STAFF RECOMMENDATION
Approval, with Conditions

CASE FILE NO.: Z0323-18-D

PROPOSAL: Design review of proposed modifications to this site including removal of certain trees, grading and site preparation, as well as the construction of 40 units of multi-family workforce housing. This project includes associated site improvements such as highway access, site circulation, parking, landscape, and tenant amenity spaces.

Site Plan

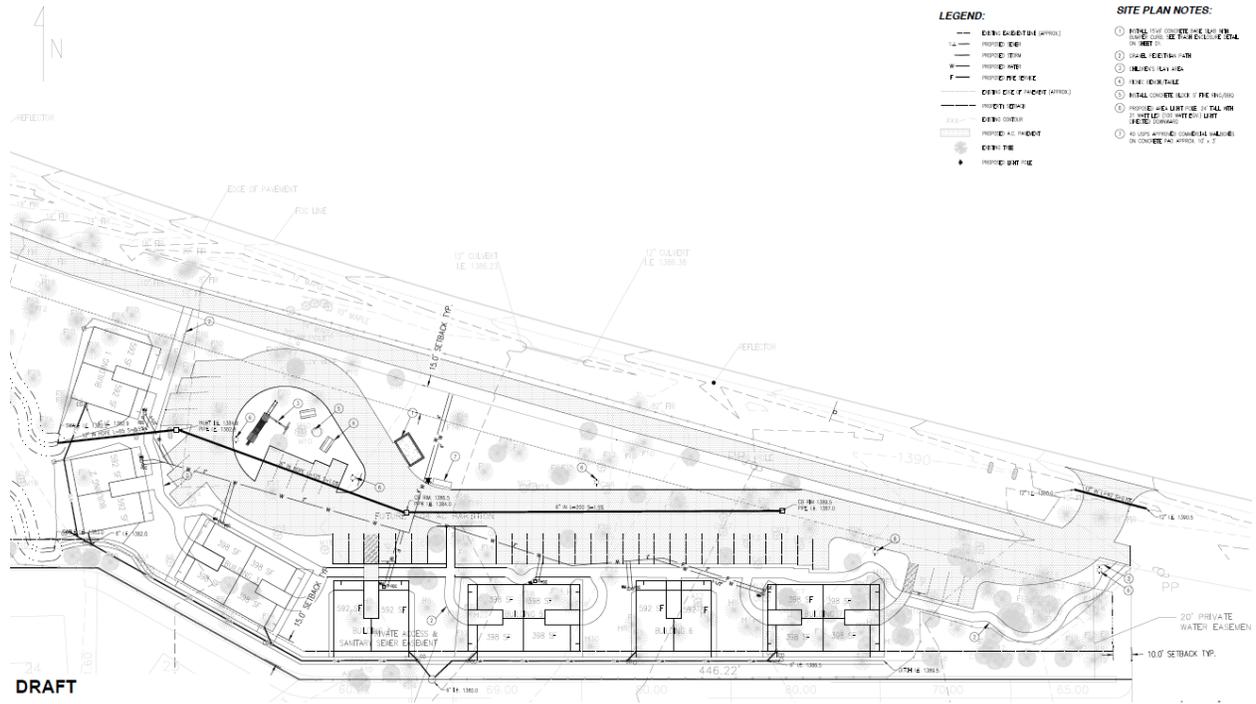
Finding: The site plan (Sheet C1) demonstrates clear compliance with these standards. Walkways are of an appropriate width and materiality and they connect buildings appropriately to surrounding properties and pathways. Separate lighting will not be required as proposed site lighting is adequate to illuminate pathways. These criteria are met.

Finding: An area for solid waste collection is indicated on the submitted site plan. The method of screening and enclosure is not sufficiently detailed to demonstrate compliance with 1009.04(C) **This does not comply with the standard. This standard can be met with a condition of approval.**

Finding: There is an area of buffering indicated on the landscape plan, as required per 1009.05(D), but there is not sufficient detail to determine compliance with 1009.05(E). **This does not comply with the standard. This standard can be met with a condition of approval.**

Finding: The provision of bicycle parking is indicated in the applicant’s narrative but no specific information about locations for bicycle parking are indicated on the site plan. **These standards can be met by condition.**

- 4) The shall provide a detailed drawing of the required buffer between the development and adjacent residential properties to ensure it complies with the appropriate criteria as identified in 1009.05(E)(1-3).

Elevation Drawings – One Bedroom Buildings

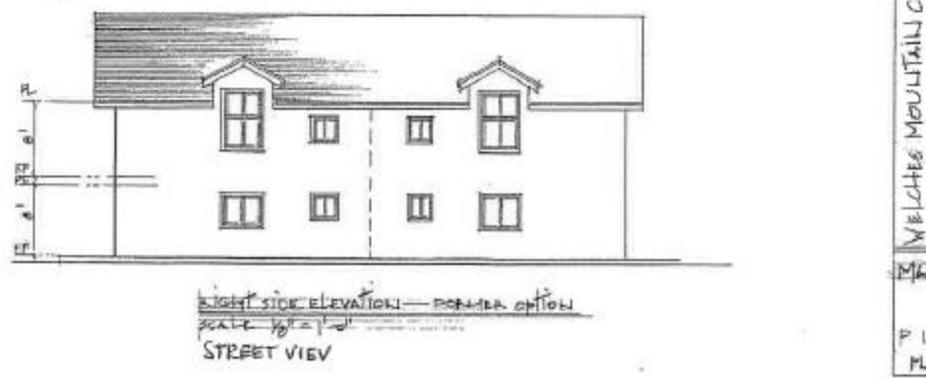
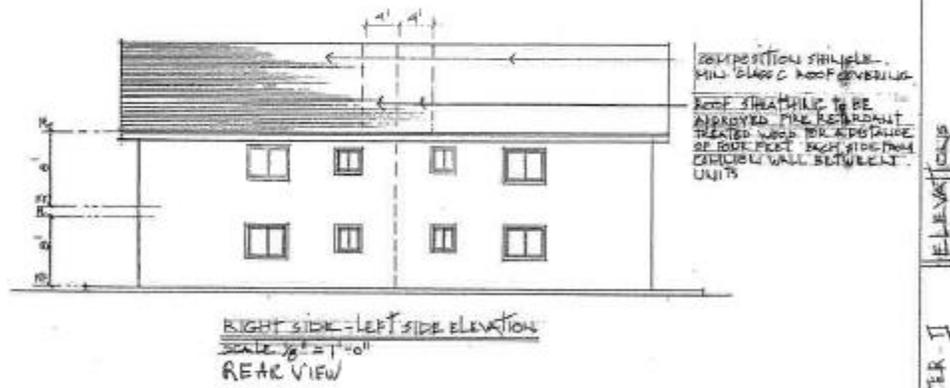
Revised 11-8-18
Label dormers as
Streetview

Finding: The proposed buildings are designed with pitched roofs and eaves project 24 inches from the building face. The revised drawings indicate the placement of roof vents on the roof plan facing opposite of the primary street. These standards are met.
